Submission on Vickery Extension Coal Mine NOISE IMPACT ASSESSMENT

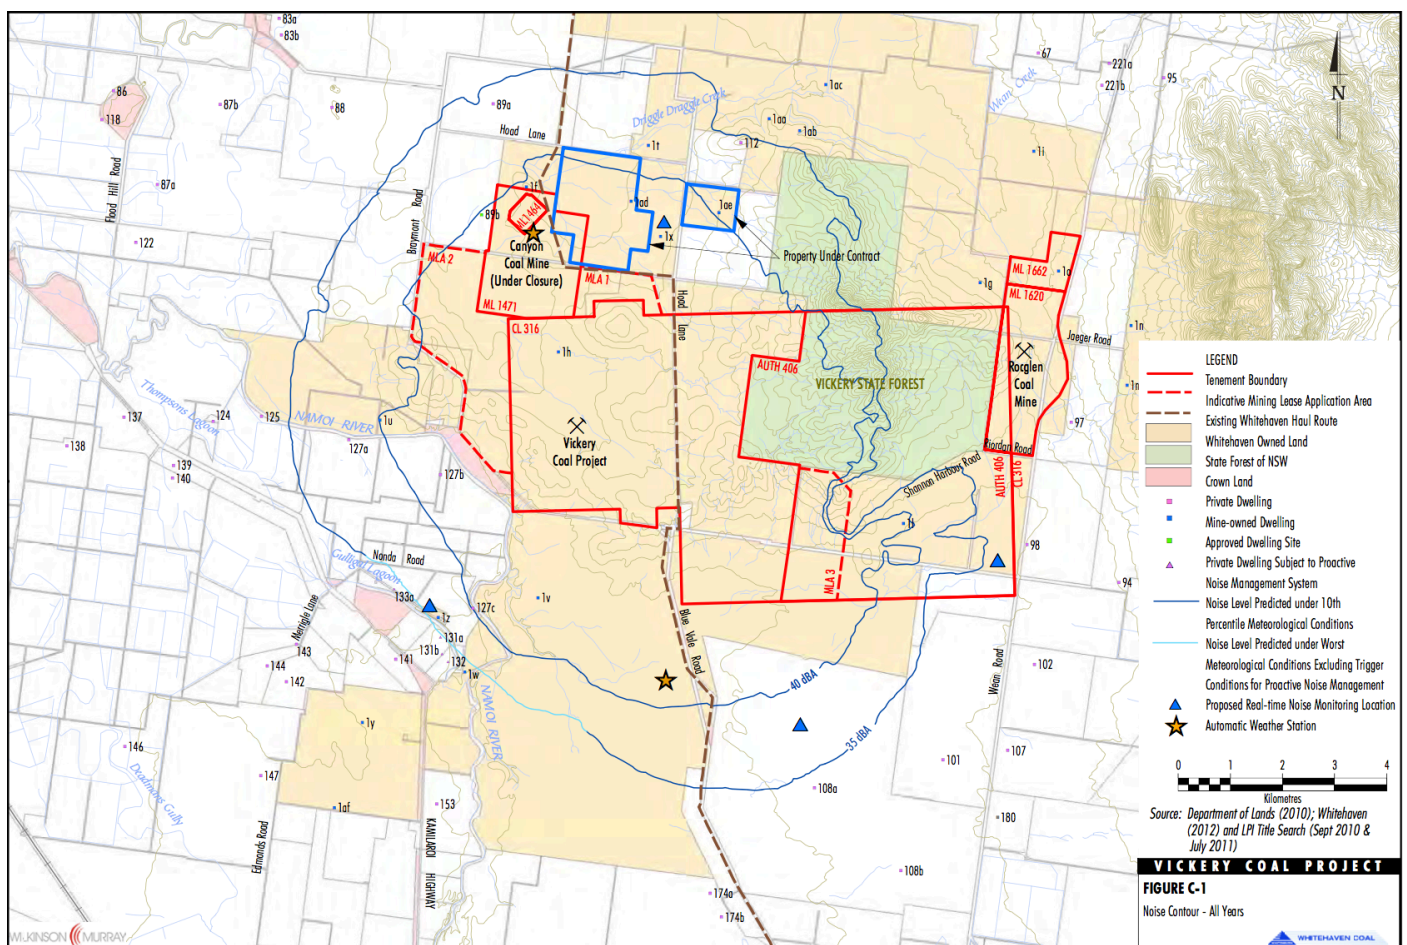
We compared the Noise Contours of the 2013 EIS and the 2018 EIS and found that the contours have become closer together, without any logical reason to justify this. Normally the change in distance between contour lines would be the results of changes in topography but clearly here that is not the case.

This anomaly calls for further investigation, preferably by a trained acoustic professional who can explain why this is so.

2018 version

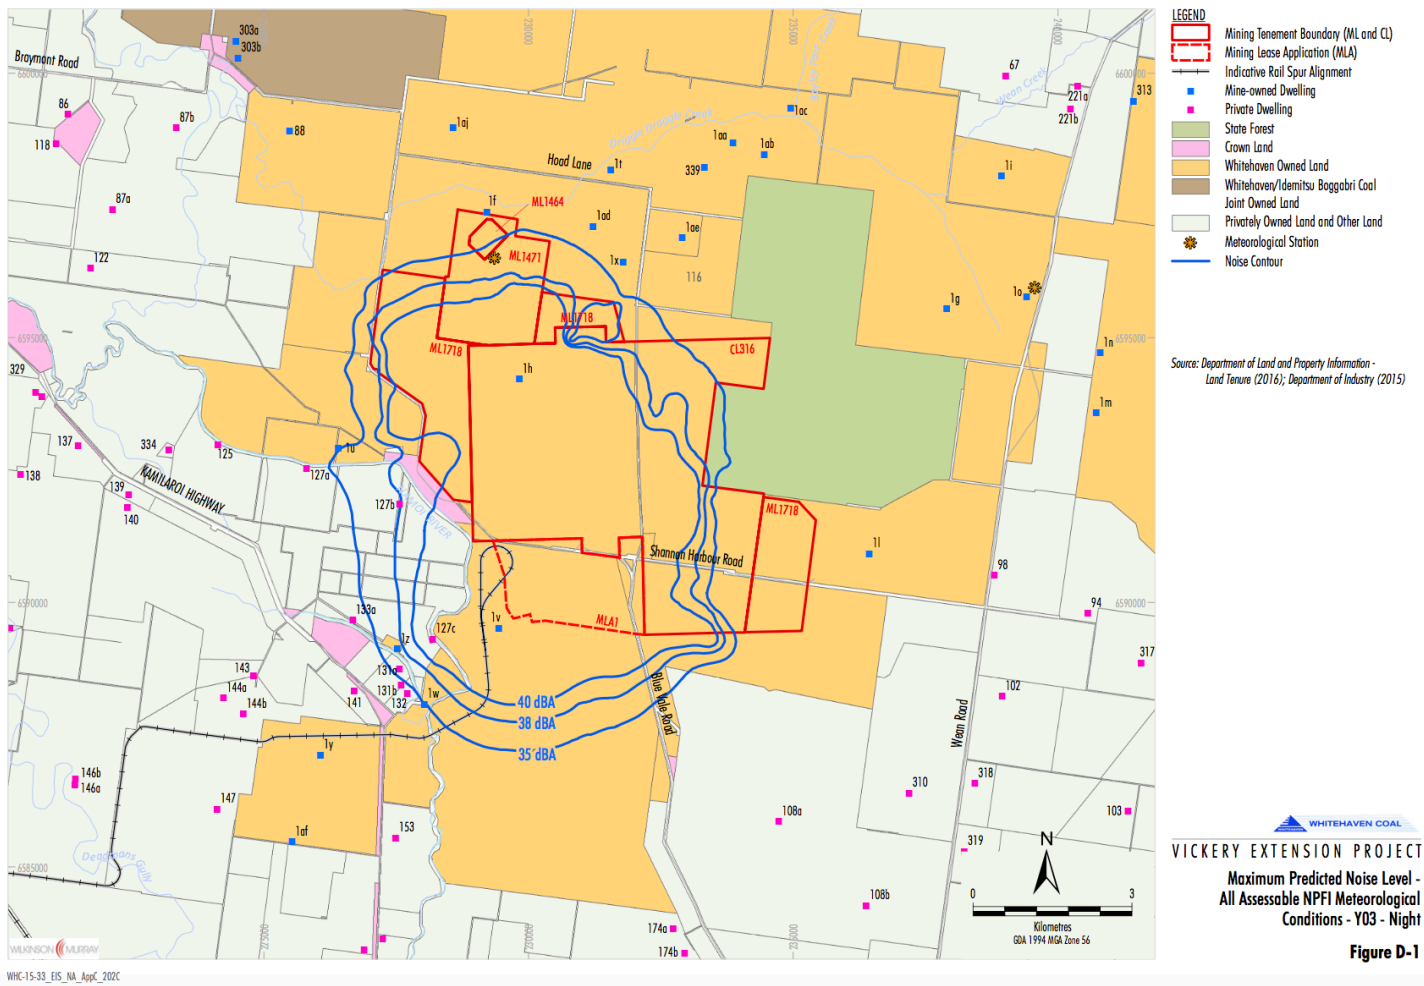
Our first review of the **2018 modelled noise contours show them to be exceptionally small** for a coal mine of that size i.e. 10 MTPA (or 7 MTPA averaged over life of mine)

This version shows how the 35dB contour has been moved dramatically closer to the mine.

This cannot be explained by the changes in the Industrial Noise Policy.
